MODEL BENTLEY MARK VI

COLUMN GEAR CHANGE(LEFT-HAND DRIVE CARS)FOR INFORMATION:

FOR INFORMATION:THE AUTOMATIC GEARBOXAddendum to BB.151.

FIG. 5. FRONT SERVO - GAUGE IN POSITION.

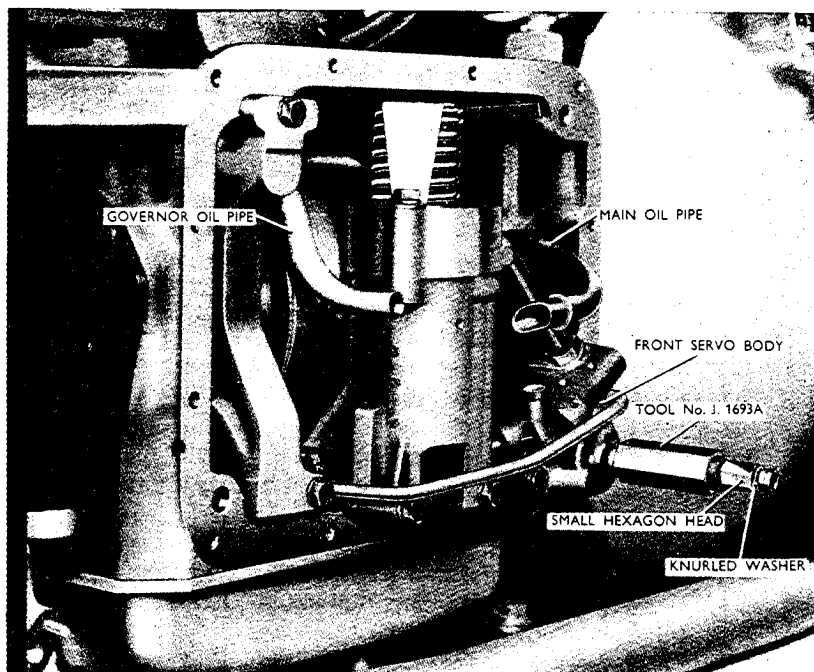
2. Smoother gear changes are obtained by setting the front gauge just to release the knurled washer at 5 turns, instead of $5\frac{1}{2}$ turns as stated in the Bulletin.

FIG. 1. DESIGN DIFFERENCES - REAR END.

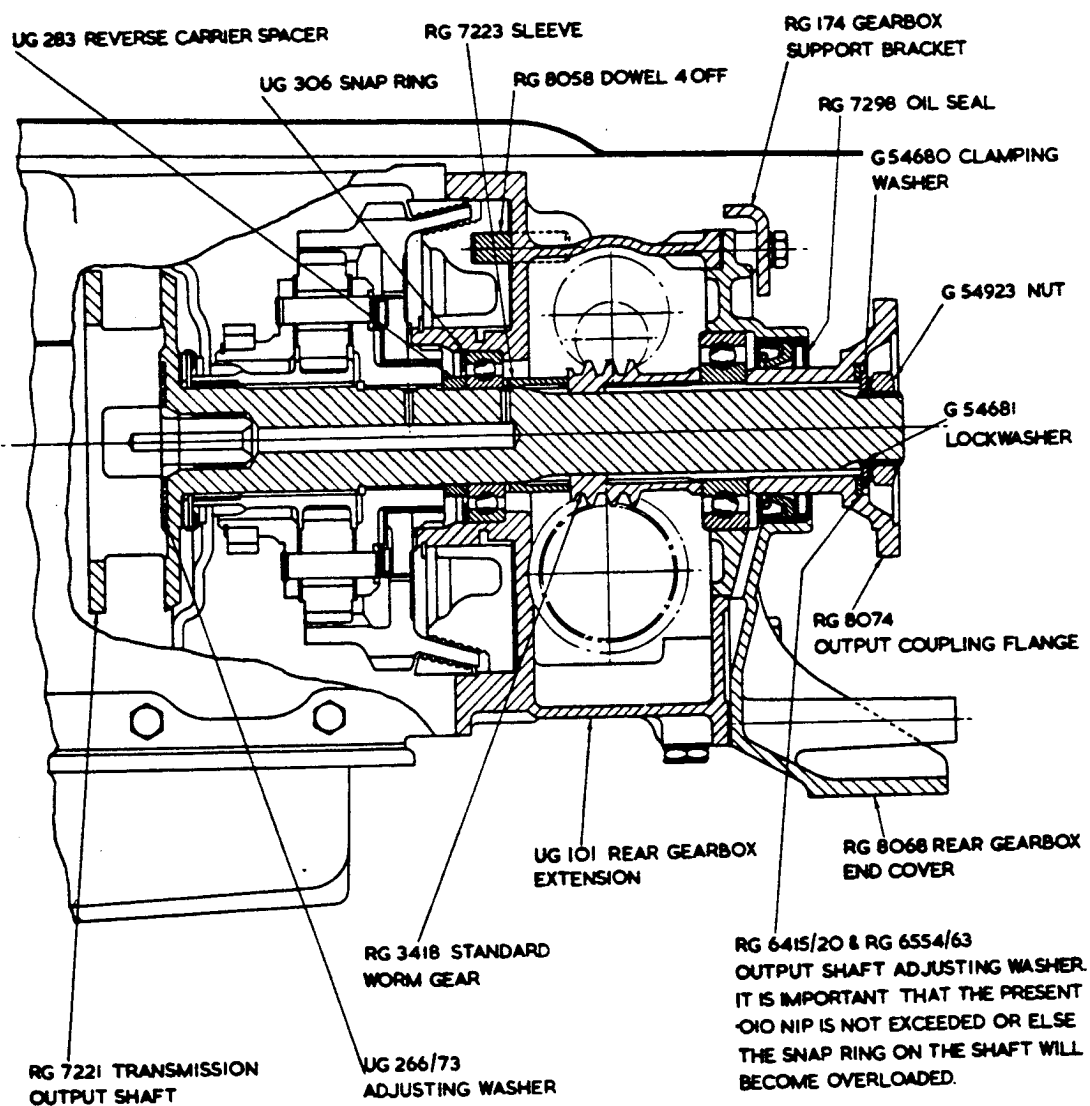
These modifications do not affect the principles of the Hydra-Matic design which remain unaltered, but allow for the incorporation of additional Bentley design features.

The main differences are embodied in the rear extension of the gearbox (see drawing attached) where the parts of Bentley design are shown in section. Original Hydra-Matic parts are shown in outline only.

The throttle-valve linkage has been re-designed to give slightly altered upshift characteristics. The manual control lever on the steering column, and the operating linkage, the starter ring, flywheel and divided bell housing are also of Bentley manufacture.

FIG.1 THE FLEXIBLE PIPE RE-POSITIONED.

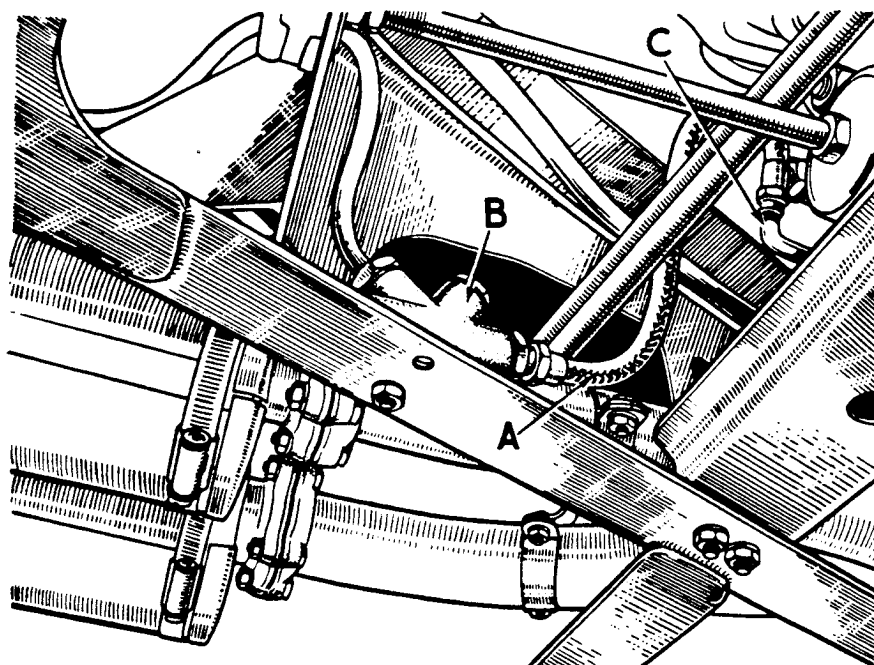
Experience has shown that, on the left hand drive Bentley 'R' Type fitted with an Automatic Gearbox, the flexible pipe from the ride control pump to the four-way union mounted on the frame cruciform member just behind the gearbox, can be burnt by fouling the exhaust pipe. In exceptional cases this may lead to considerable loss of oil from the gearbox, which, although causing no permanent damage, will give rise to immediate erratic and noisy operation. A shorter pipe, Part No. RF.9971, has been fitted on production on chassis No. B-20-UN and from B-26-UN onwards.

Retailers should check all left-hand drive 'R' Type Bentleys, fitted with an Automatic Gearbox, in their area at the earliest opportunity on service and if necessary, reposition the flexible pipe as described below.

- A. Repositioned Flexible Pipe. C. L-Shaped Outlet Pipe.
B. Four-Way Union.

FIG.1 EXPLODED VIEW OF
RIDE CONTROL
PUMP.

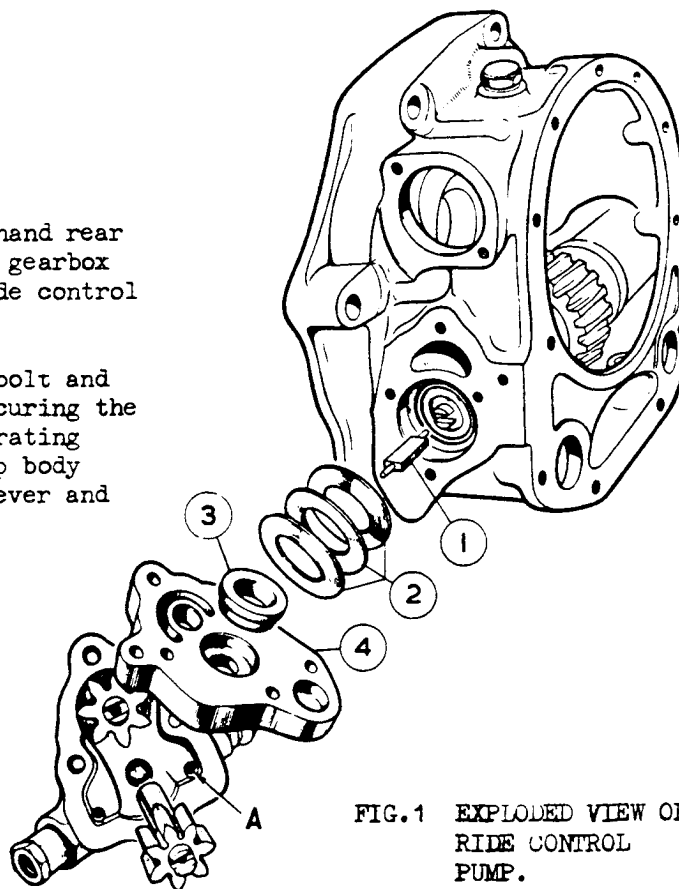
This Bulletin details the method of correction and incorporates a modification for increasing the diameter of the pump intake passage, which further improves its operation.

- (i) Remove the left hand rear shield under the gearbox to expose the ride control pump.
- (ii) Remove the nut, bolt and spring washer securing the ride control operating lever to the pump body and remove the lever and bracket as one.

VIEW LOOKING FROM FRONT OF CAR SHOWING
MODIFICATION TO EXISTING TIE ROD BRACKET

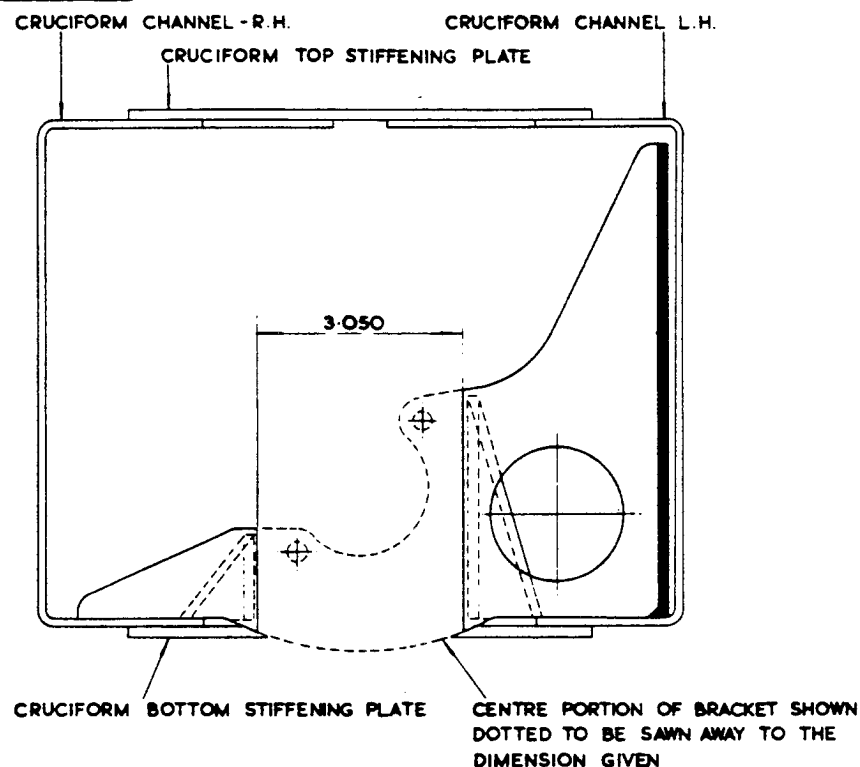
3. WELDED FRAMES MODIFICATION

- (i) Place the car on a ramp or over a pit.
- (ii) Remove the gearbox tie-rod by removing the two nuts and spring washers retaining the rubber seatings to the gearbox at the front end and to the mounting bracket at the rear end.
- (iii) Cut out the centre portion of the transverse mounting bracket with a hacksaw as shown in Fig.3. Clean up and paint the cut edges.

FIG. 3 TO MODIFY THE THIRD MOTION SHAFT
RG.5469 to RG.8530.

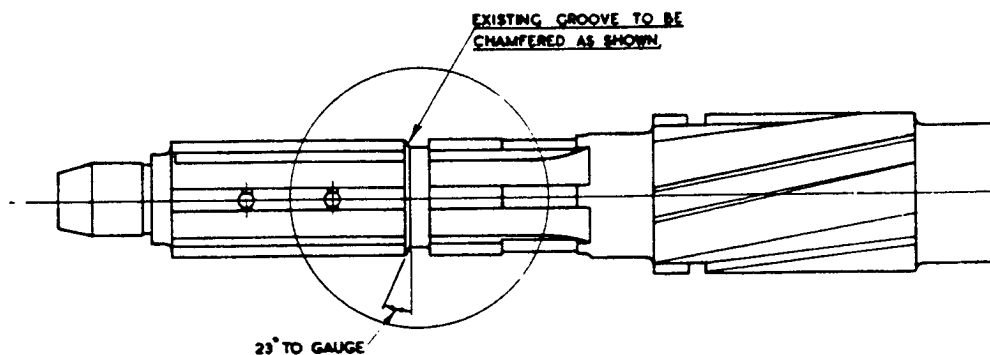
RG.8529 Thrust Washer-3rd Motion Shaft	1 Off
RG.8530 3rd Motion Shaft	1 Off
or RG.5469 modified to RG.8530 (Fig.3)

The chamfer on the front face of the groove in the third motion shaft should be ground off if necessary using the thrust washer itself as a gauge. The washer should rotate freely in the groove but endfloat must not exceed .004" (.10 m/m).

FIG. 4 TO MODIFY 3RD MOTION SHAFT
RG.5469 to RG.8472

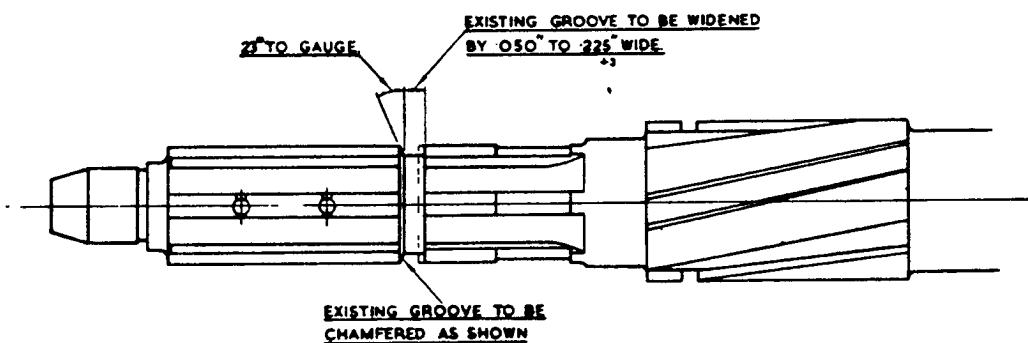
RG.8473	Thrust Washer-3rd Motion Shaft	1 Off
RG.8472	3rd Motion Shaft (or RG.5469 modified to RG.8472 - Fig.4)	1 Off
RG.8459	3rd Speed Gear (or RG.100 modified to RG.8459 - Fig.5)	1 Off
RG.8461	Sleeve - 3rd Motion Shaft (or GB.5374 modified to RG.8461 - Fig.6)	1 Off
RG.8467	Sliding Piece - 3rd Motion Shaft (or RG.5470 modified to RG.8467 - Fig.7)	1 Off

The machining operations are detailed in Figs. 4, 5, 6 and 7. The sleeve RG.8461 may be turned in a lathe using a carbide tipped cutting tool but other parts should be ground. The machining of the 3rd speed gear requires an internal grinding machine.
